NOTICE AND AGENDA
Regular Meeting & Work Session to follow regular meeting
Idaho Springs Planning Commission
1711 Miner Street, City Hall
Wednesday, May 1, 2024 – 6:00 p.m.

A. Request for Amendments to the Approved Final Development Plan (FDP) for the Block 57 / Former Golddigger Field Mixed-Use Project

IDAHO SPRINGS
PLANNING COMMISSION STAFF REPORT

Meeting Date: Monday, May 1, 2024	**Page 1 of 5**	**Item:** **Request for Amendments to the Approved Final Development Plan (FDP) for the Block 57 / Former Golddigger Field Mixed-Use Project**
Presented by: Dylan Graves Community Development Planner

Location of parking lot proposed for removal:

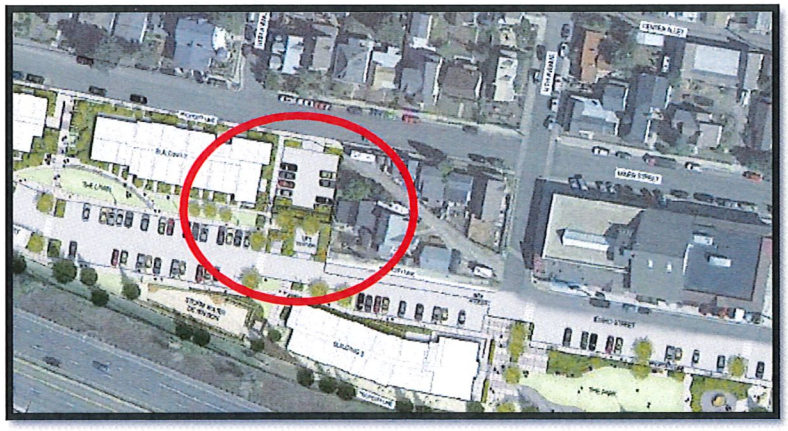
2. *Removal of parking lot/access East of Building 2, eliminating Miner Street access onto property and revised parking in other lots on the South of the property*

The second proposed modification is the removal of a parking area directly East of Building 2, which as approved contained ten (10) parking spaces, two of which were disability spaces. The approved FDP required 172 parking spaces and the applicant showed 177 provided spaces in the approved FDP. This included 26 spaces on the south side of Miner Street, 127 in the main parking lot accessed off Idaho Street, 10 spaces on the parking lot proposed for removal, and 25 spaces along Idaho Street itself.

The reason for the change is that the applicant's civil engineering team has advised that they cannot accommodate the grades required to access the parking lot. The entrance grade as proposed would have to be too steep to accommodate the spaces in that location. It would also require a 9' tall, tiered retaining wall, which can be eliminated by reallocating required parking elsewhere on-site. Once the applicant determined that additional spaces could be allocated elsewhere, the applicant decided that eliminating this proposed parking lot would be their preferred option. An engineering review completed on April 5, 2024, noting the civil issues with the parking lot is included as Attachment 3.

The proposed amendment will remove the 10 spaces from the east parking lot but will add seven (7) spaces to the existing large parking lot accessed from Idaho Street and will add two spaces to the south side of Miner Street. The net reduction in parking will thus be one (1) parking space. This continues to exceed the 172 parking spaces that were required as part of the original FDP approval. Six (6) ADA parking spaces will remain, as was approved originally.

A benefit of the proposed change is the removal of one access off Miner Street. This reduces the number of places along Miner Street where vehicles can enter the City's roadway system. It also adds the ability to fit two additional parallel parking spaces on the south side of Miner Street. Finally, it increases the amount of open space on site, which will be adjacent to property owners to the East of the development. This improves stormwater drainage off of Miner Street while also creating additional open space buffer between adjacent properties and the subject development.

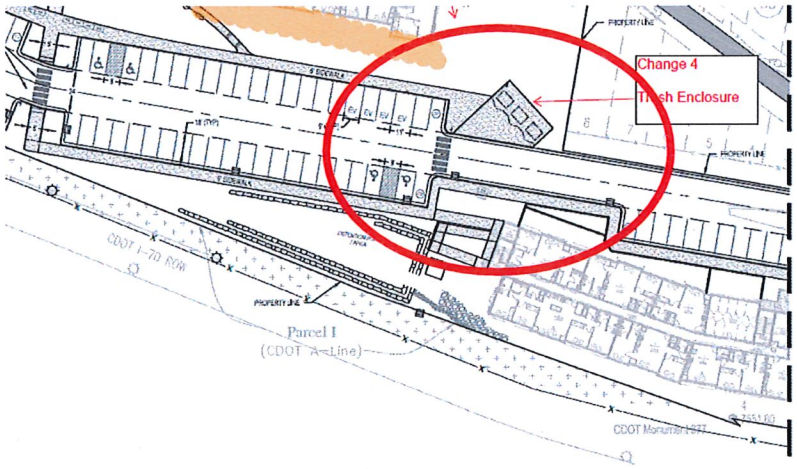
4. *Revised trash enclosure plan*

The final proposed amendment is to the trash enclosure plan that is approved for the development. The current approved FDP shows two (2) small trash enclosures, each located in the south parking lot – one to the south of Building 1, the other to the south of Building 2 and west of Building 3. The applicant has discussed trash management with Timberline Disposal – a local waste management company – who has advised that the current layout of the trash enclosures would require the dumpsters to be manually wheeled out to the truck rather than allowing a truck to directly access the dumpsters within the enclosure. Based on that need, the space required for trash enclosures would expand beyond what the approved enclosure areas would allow, necessitating the change. Given that, the applicant proposes to combine the trash enclosures into one larger, central enclosure on the southeast corner of Building 2:

This would centralize the waste management facilities on-site while also opening several spaces for additional surface parking within the lots to accommodate the relocated spaces from the other parking lot that is proposed for elimination. The proposed dumpster enclosure is designed to hold three eight-cubic-yard dumpsters.

The downside to this revised location is that residents of Building 1 will be required to walk further to dispose of waste, since on-site trash enclosures are further now than when smaller enclosures were proposed across the site. Nevertheless, the proposal as designed appears to meet City requirements for the provision of waste management facilities for multi-family/mixed-use development.

The original design has two trash enclosures that are perpendicular to the parking lot. This means, any trash truck has to manually wheel the dumpsters out of the trash area in order to service them. After speaking with Timberline Disposal they informed us the largest wheelable dumpster 4 cubic yards so we would need 4 or 5 of these to service the community. If we keep the enclosures perpendicular to the parking area, we will need to add more dumpsters, thus reducing the parking availability. We believe the best option is to create a dedicated trash enclosure on the southeast corner of Building 2. The enclosure will be constructed with similar materials as shown in the approved Final Development Plan.

1 SITE PLAN
A5.30 T0.10 SCALE: 1" = 40'-0"

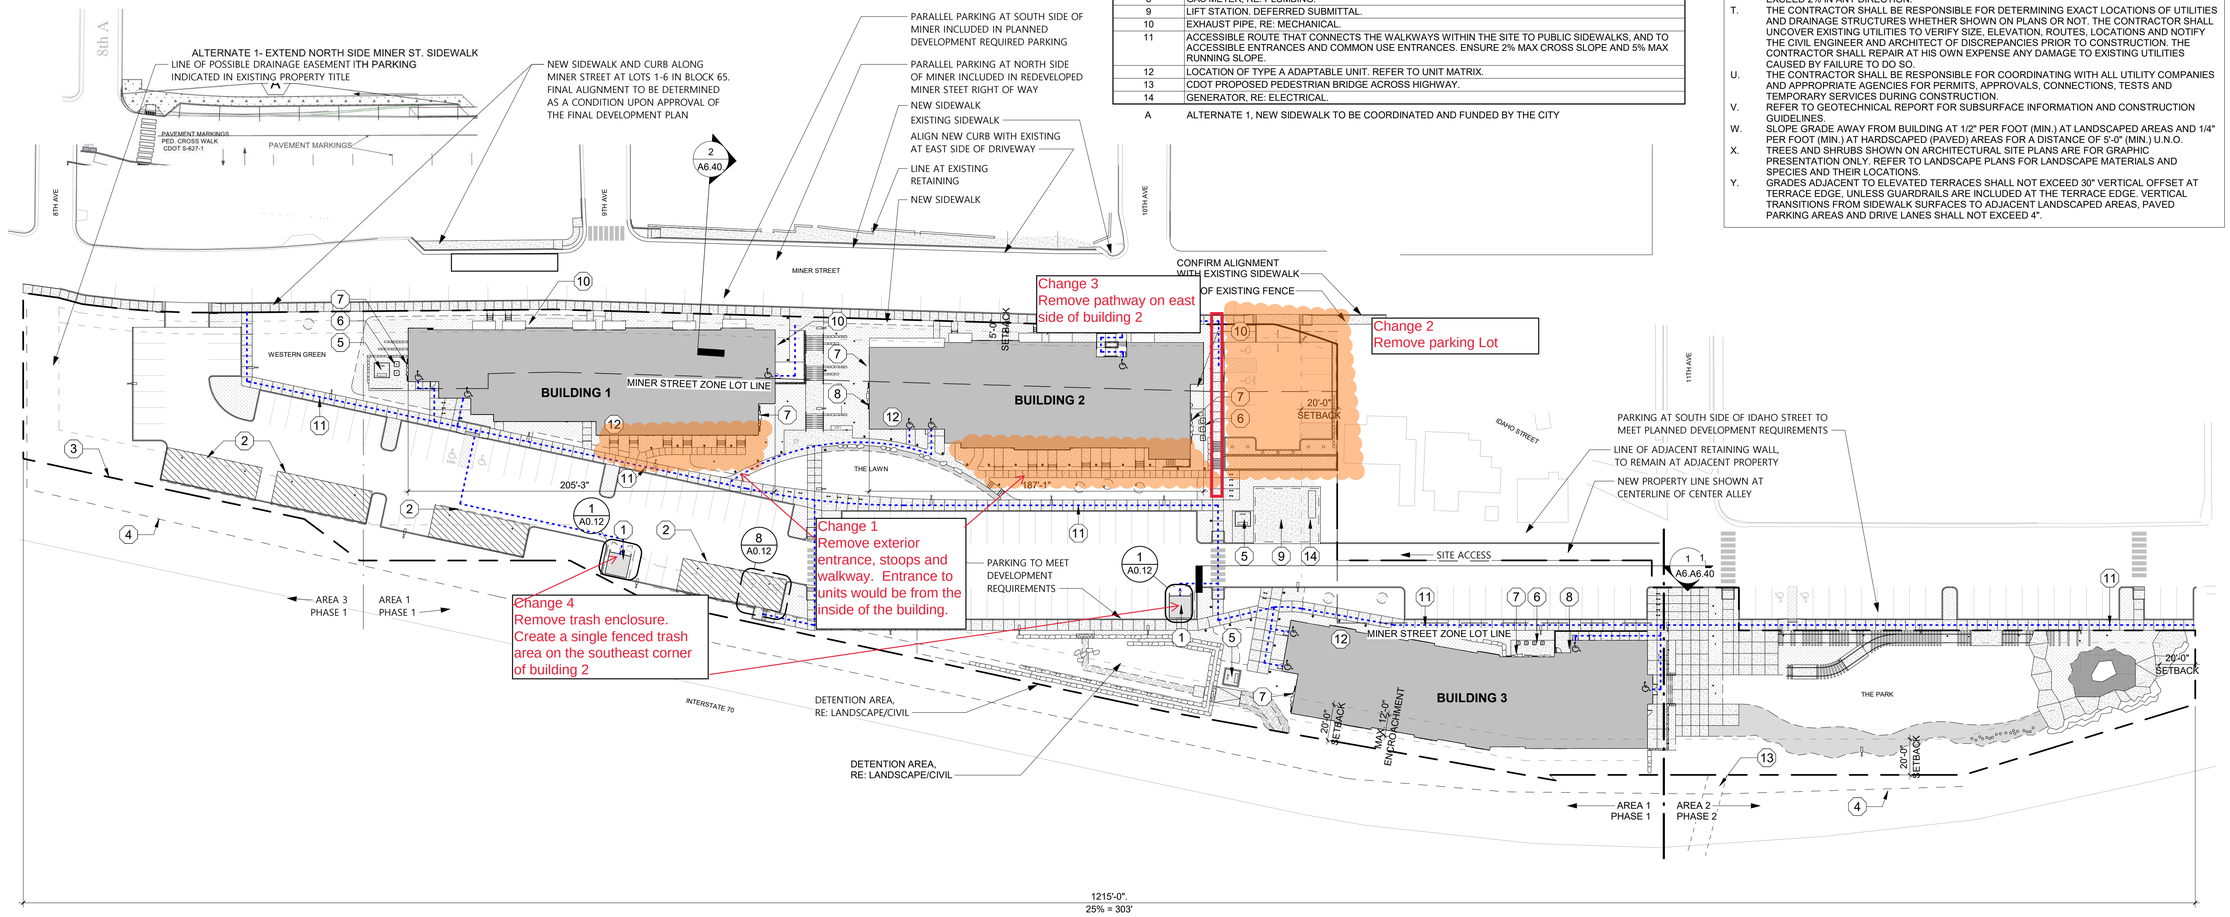
1. Removal of sixteen (16) exterior doors on the South façade of Building 1 and Building 2
2. Removal of parking lot/access East of Building 2, eliminating Miner Street access onto property and revised parking in other lots on the South of the property
3. Removal of walkway adjacent to Building 2/parking lot proposed for elimination
4. Revised trash enclosure plan

LOWER SITE PLAN - WEST

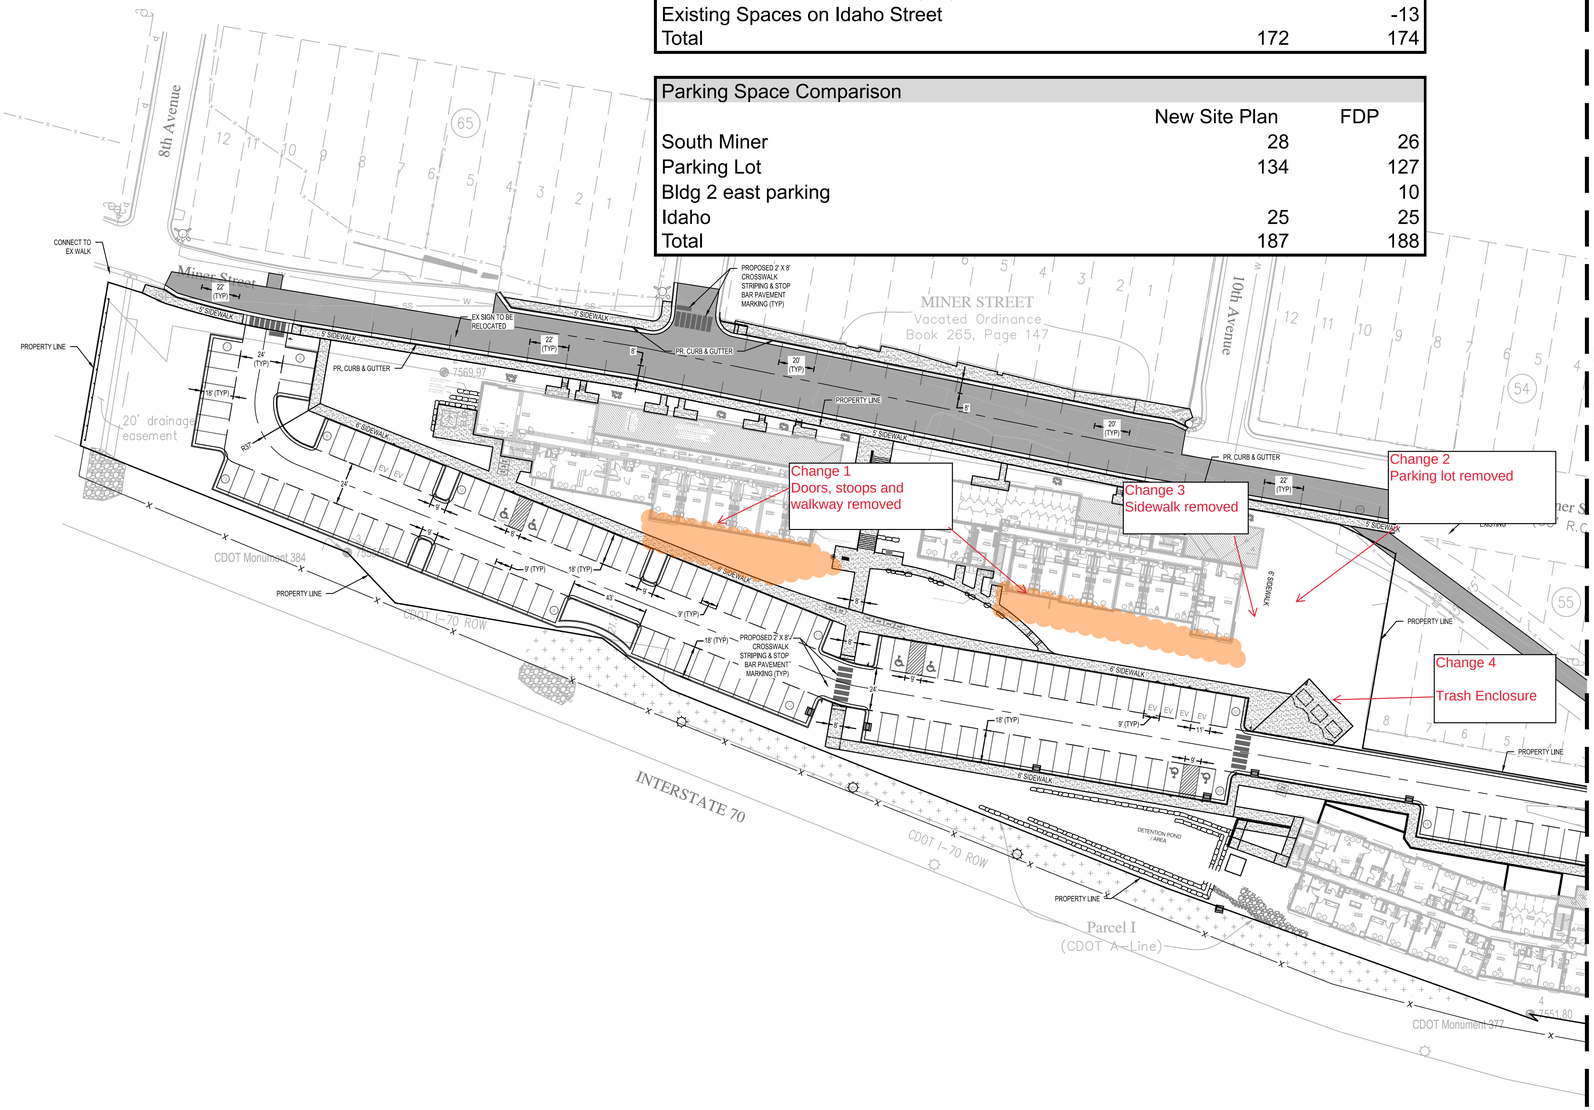
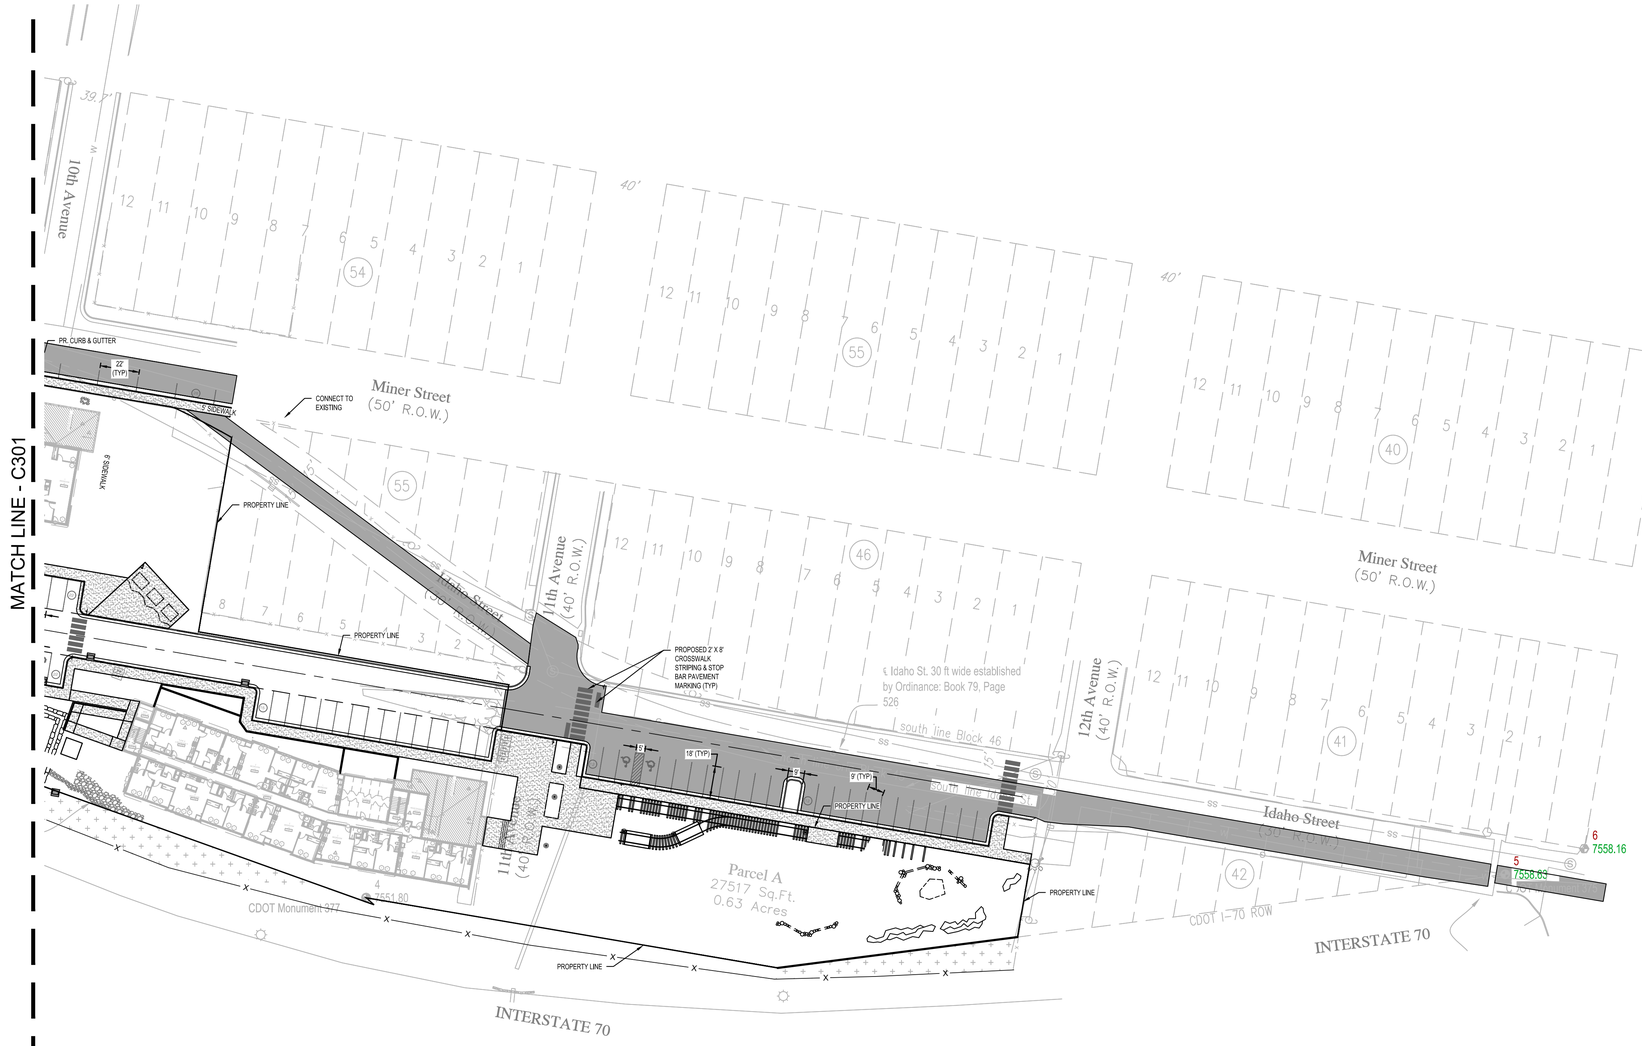
Parking Space Comparison	New Site Plan	FDP
South Miner	28	26
Parking Lot	134	127
Bldg 2 east parking		10
Idaho	25	25
Total	187	188

Proposed Building 1 South Elevation

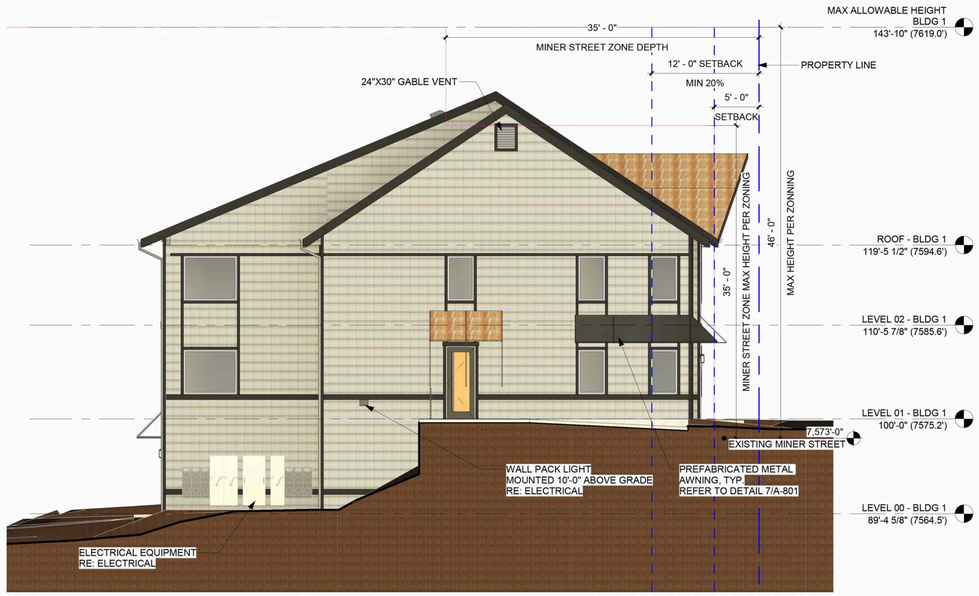
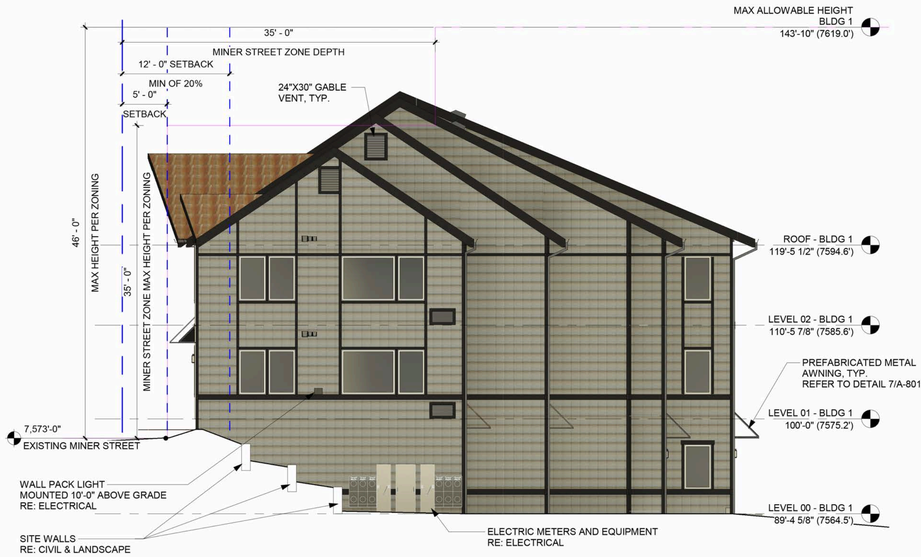
The requested revision modifies the Southern façades on Building 1 and Building 2 facing the approved parking lot for the development. The effect of the revision would be to replace the doors, as approved on the existing FDP, with windows. In association with this change, they would be removing the patios and walkways that were approved to allow pedestrian access to said door from the south parking lots. The units that would be impacted have access through the interior corridors of the buildings, which is proposed to remain unchanged.

Remove the exterior unit entrances, patio's and walkway to sixteen (16) units on Level 00 facing I-70. This desired change is based on the use of the interior space and security. Fourteen of the sixteen units are 450 SF studios. Due to the limited SF, we believe it is important to make as much of this interior space as usable as possible. The swing of the exterior door and subsequent entrance pathway into the unit affects the "living room" area of the apartment. By eliminating the door, it creates a much more usable "living room" area. Secondly, the exterior entrance directly to the parking lot, creates a potential security risk for these residents. By removing this entrance, all residents would enter through the locked corridor entrance. The corridor entrances will be locked at all times, accessed by either key card or physical key by the residents, which allows the Property Managers to control who enters the building.
